SITE PLAN MODIFICATION
505 WEST CENTRAL STREET
LOT 3
(515 WEST CENTRAL STREET)
FRANKLIN
MASSACHUSETTS
FIELD CHANGE
PLAN

SEPTEMBER 25, 2023

PROPOSED FIELD CHANGES

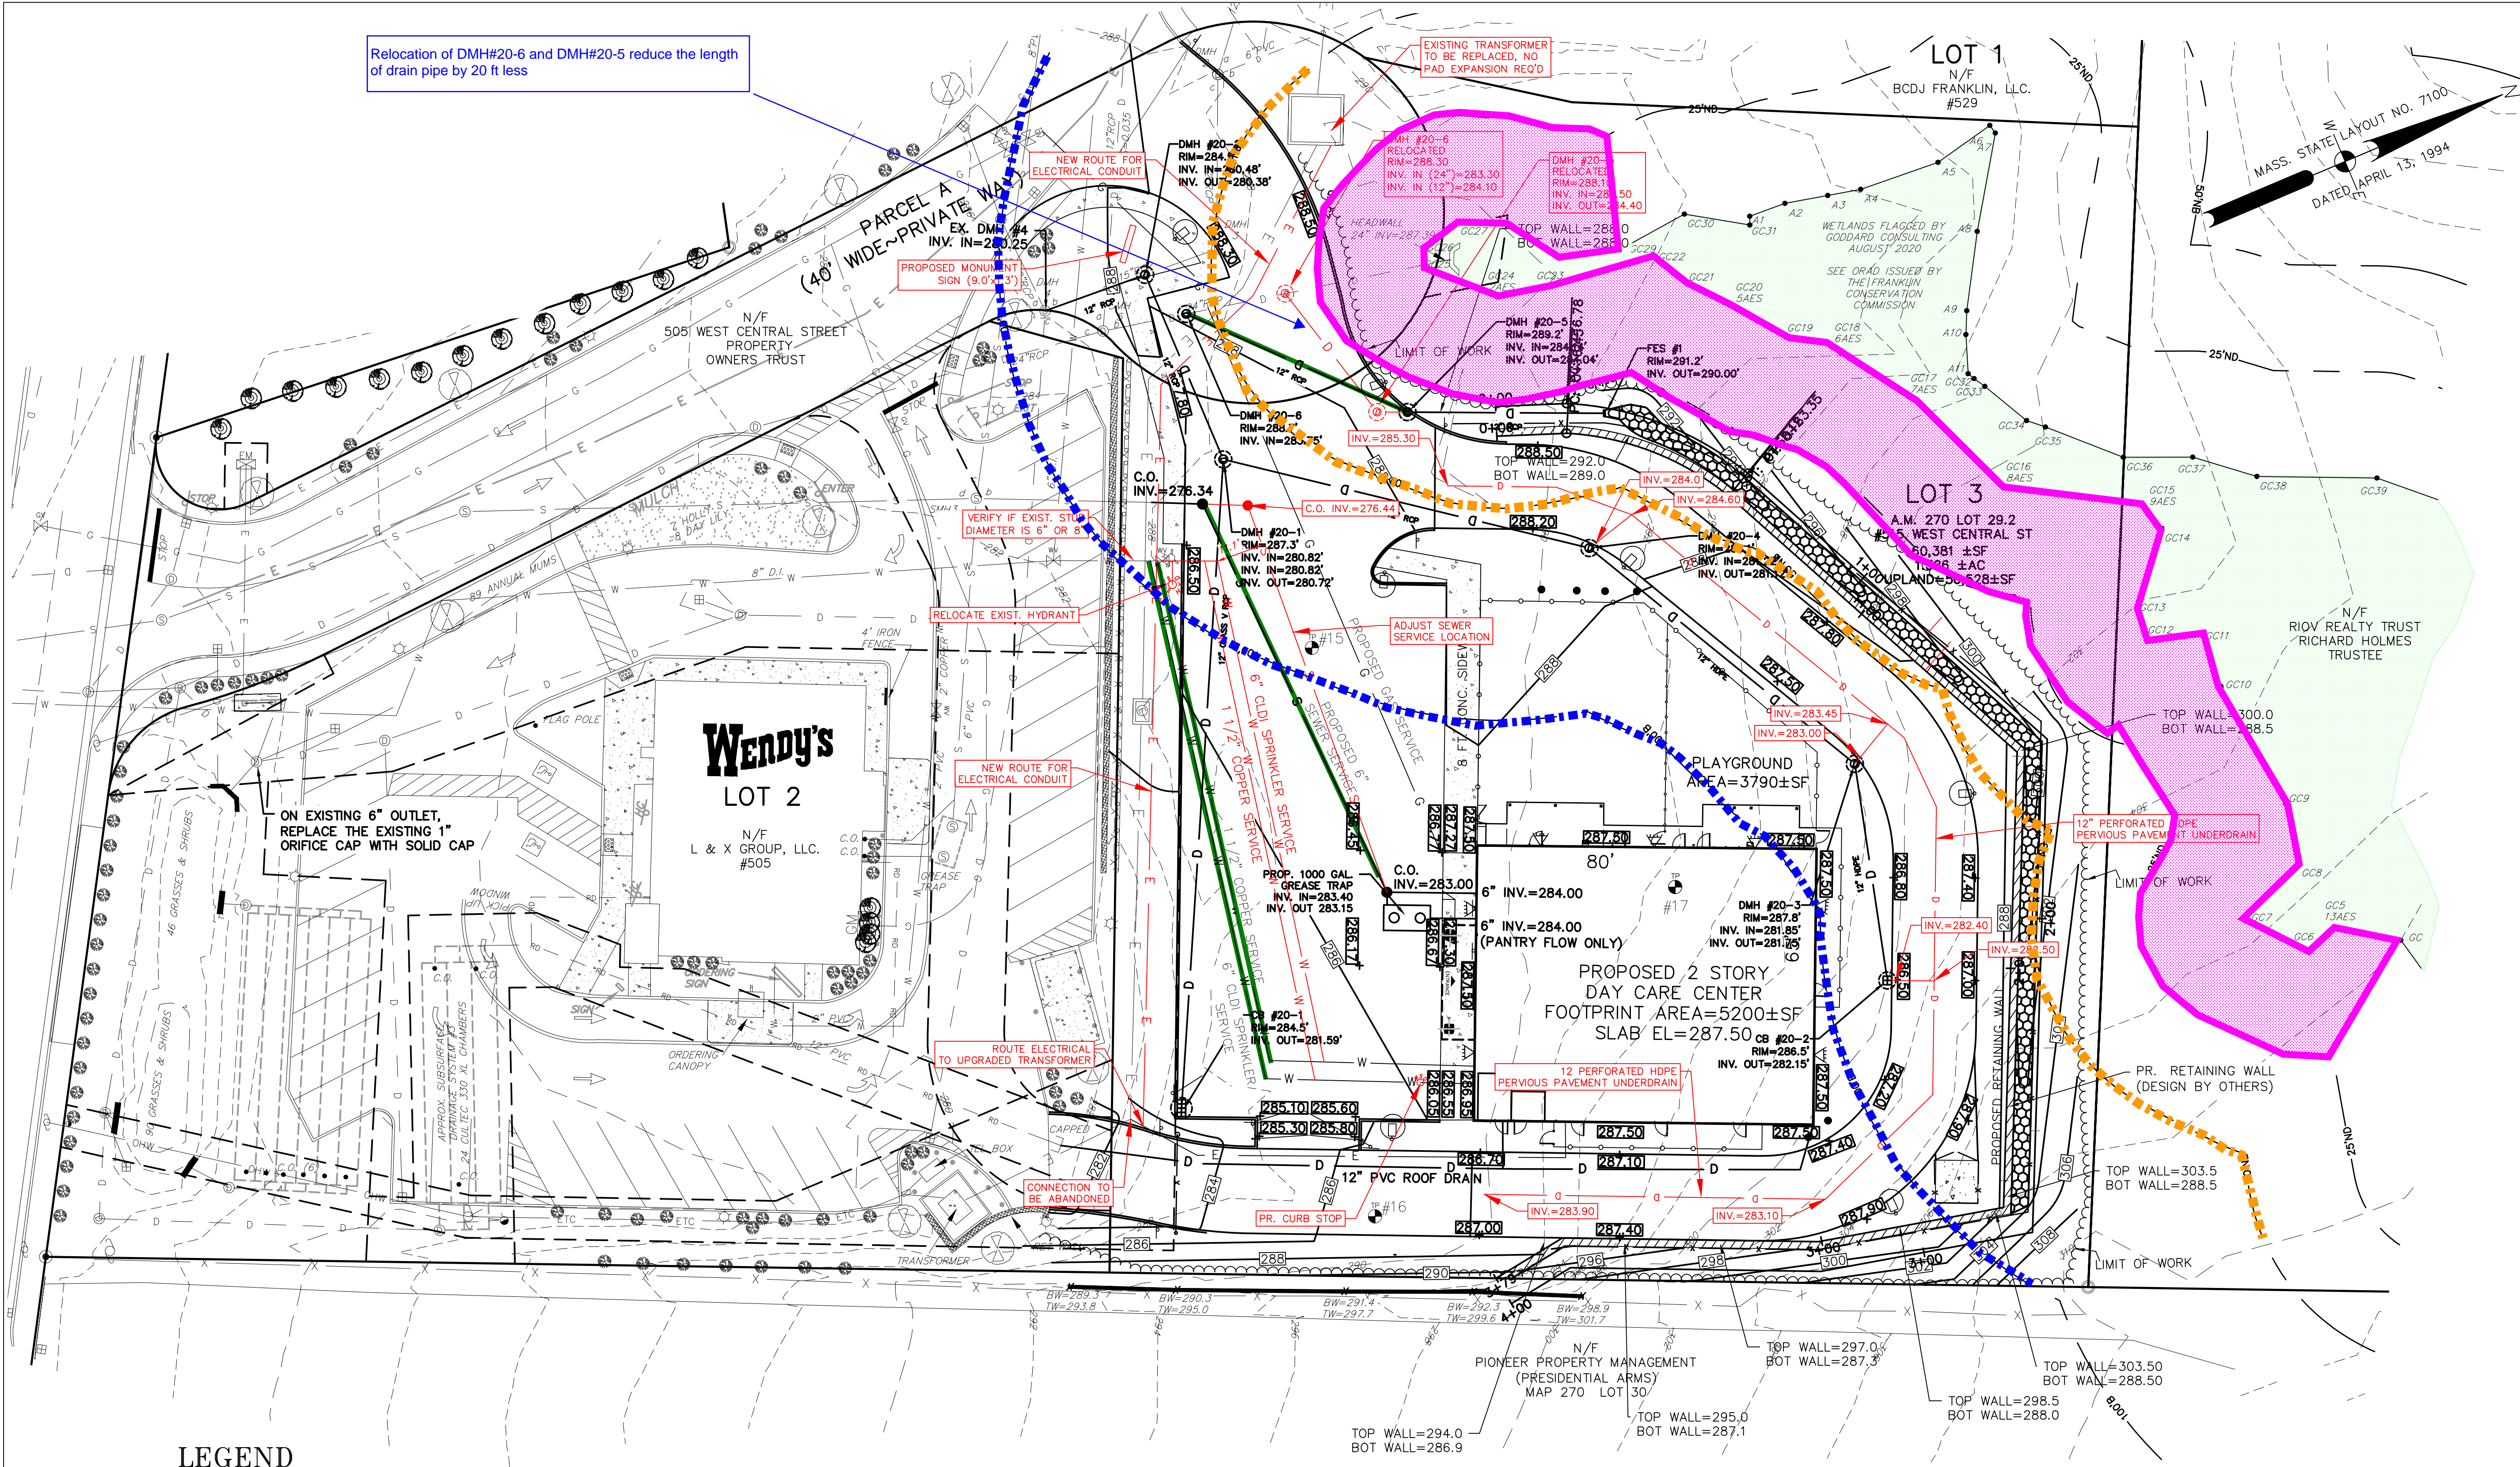
Relocation of DMH#20-6 and DMH#20-5 reduce the length of drain pipe by 20 ft less

- STORMCRETE PERVIOUS PAVERS TO BE REPLACED BY PERMEABLE PAVEMENT. DUE TO LEDGE AND PERSISTENT HIGH GROUNDWATER BENEATH THE REAR ACCESS ROAD, INSTALLATION OF AN UNDERDRAIN CONNECTED TO THE STORMWATER CHAMBERS IS PROPOSED.

- THE PROPOSED WALL DESIGN IS TO BE A TERRACED DESIGN PREPARED BY MARK SANTORA, P.E. INC. INSTALLATION OF A SUBDRAIN 4" BELOW THE PROPOSED RETAINING WALL IS PROPOSED TO INTERCEPT GROUNDWATER ENTERING THE SITE, AND WILL CONNECT TO DMH #20-5.

- DMH #20-5 AND DMH #20-6 LOCATIONS ADJUSTED TO AVOID CONFLICTS WITH EXISTING AND PROPOSED UTILITIES.
- EXISTING TRANSFORMER AT SITE ENTRANCE TO BE UPGRADED, AND NEW ELECTRICAL SERVICE CONDUIT INSTALLED PARALLEL TO THE EXISTING RUN.

- FIRE AND DOMESTIC SERVICE CONNECTIONS TO BE MODIFIED TO ACCOUNT FOR FIELD CONDITIONS. CONTRACTOR TO VERIFY DIAMETER OF EXISTING STUB. EXISTING HYDRANT TO BE RELOCATED. SEWER SERVICE TO BE ADJUSTED TO MAINTAIN MIN 10" SEPERATION TO WATER SERVICES.

- MONUMENT SIGN PROPOSED AT SITE ENTRANCE.
